Work Order ID 95260

Item Name: Crosstube Fwd High

D212-664-141/-141B
ASSEMBLY DETAIL

DRAWING NO. D212-664-141	TITLE XTUBE ASSY (205/212/412 HI FWD)	REV. D	DART AEROSPACE LTD ENGINEERING ORDER		D.E.O. NO. D212-664-141-D-1	SHEET NO. SHEET 1 OF 2	SCALE NTS
DRAWN	CHECKED	MP	MFG. APPR.	APPROVED	MP	DE APPR.	
DATE 11.04.07	DATE 11.07.11		DATE 11.04.12	DATE 11/04/12		DATE 11.04.12

**D212-664-141/-141B
ASSEMBLY DETAIL**

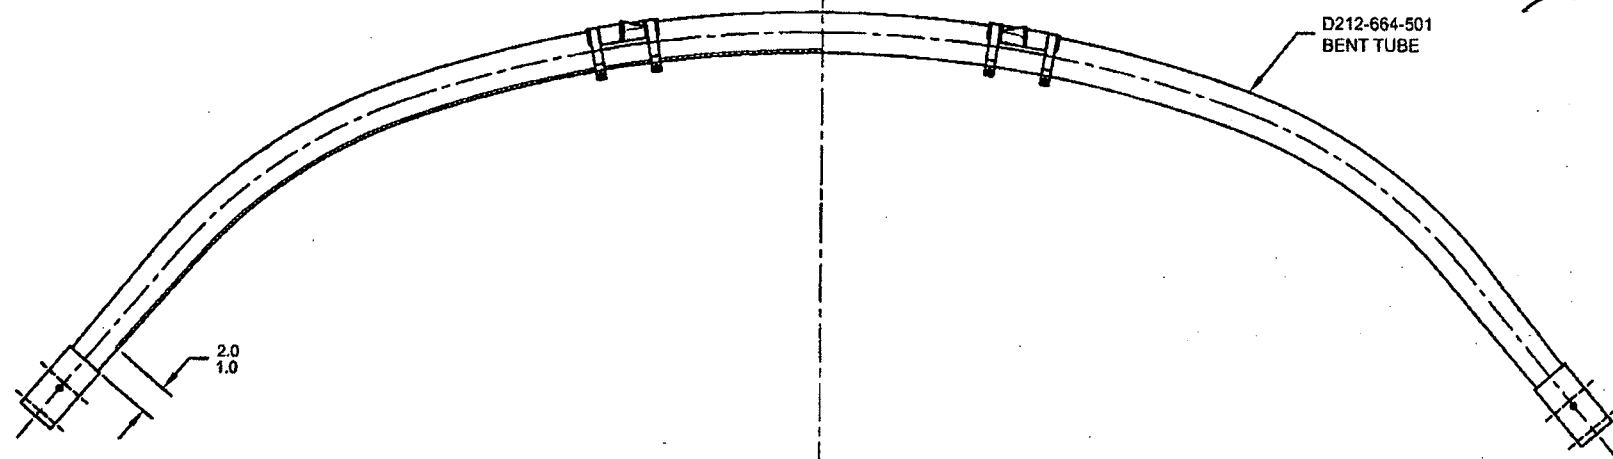
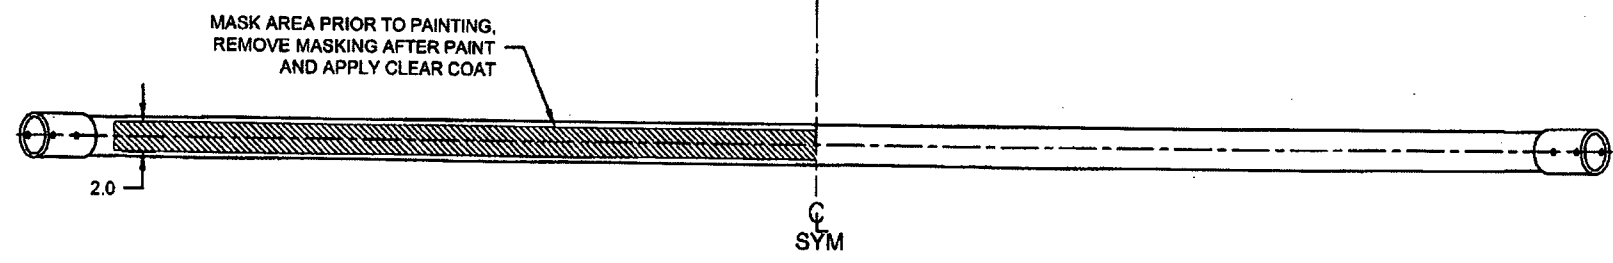
ADD AN INSPECTION WINDOW TO UNDERSIDE OF CROSSTUBE.

NOTES 2 OF SHEET 1 IS AMENDED AS FOLLOWS:

- 2) FINISH: CHEMICAL CONVERSION COAT PER DART QSI 005 4.1
PRIME INSIDE AND OUTSIDE PER DART QSI 005 4.2
MASK UNDERSIDE OF CROSSTUBE AS SHOWN (HATCHED AREA) AND
PAINT OUTSIDE PER DART QSI 005 4.2
REMOVE MASKING AND APPLY CLEAR COAT
